**Department of Community and Economic Development  
Planning Division  
ADMINISTRATIVE POLICY/CODE INTERPRETATION**

**ADMINISTRATIVE  
POLICY/CODE  
INTERPRETATION #:** CI-61

**SUBJECT:** Title Reports

## DETERMINATION OF BUILDING HEIGHT

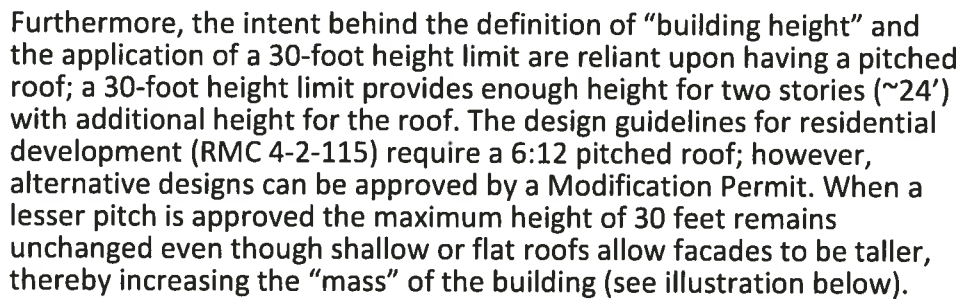
The definition contradicts itself because it states that the measurement is to “the average height of the highest roof surface” (i.e., midpoint between the eave and apex), but the graphic implies the average would be the distance between the top of the wall plate and the apex of the roof. Besides being contradictory, the definition omits any portion of a building that lies below the grade plane and any portion that exists above the midpoint of the roof. The definition provides a means to measure “building height” if there is a roof surface, but any structure without a roof surface (e.g., decks, railings, etc.) is effectively unregulated.

Although the “maximum height” in all zones from RC to R-14 is 30 feet (35’ in the RMF zone), because building height is measured from the grade plane to the roof midpoint, a building that is only 30 feet tall (per RMC) can have a facade over 30 feet tall and an effective height close to 40 feet. The same structure that is effectively taller than 30 feet can have non-roofed additions (e.g., decks) that extend even higher.

Because the definition does not address non-roofed structures and does not acknowledge portions of roofed structures above the roof midpoint, an accurate measurement of building height is undeterminable per Title IV, and therefore regulating the height of roofed and non-roofed structures with the application of a “maximum height” (RMC 4-2-110.A) is unclear.

In the RC through RMF zones, residential and accessory structures shall be subject to the maximum wall plate height standard, defined as the vertical distance from the grade plane to the highest wall plate. Wall plates shall not exceed 24' in height (except structures in the RMF zone, which shall be granted 30' of wall plate height based on the current building height limitation of 35'). Roofs pitched at a 4:12 slope or greater may project an additional six vertical feet from the maximum wall plate height. Common rooftop features, such as chimneys, may extend an additional four feet from the roof surface.
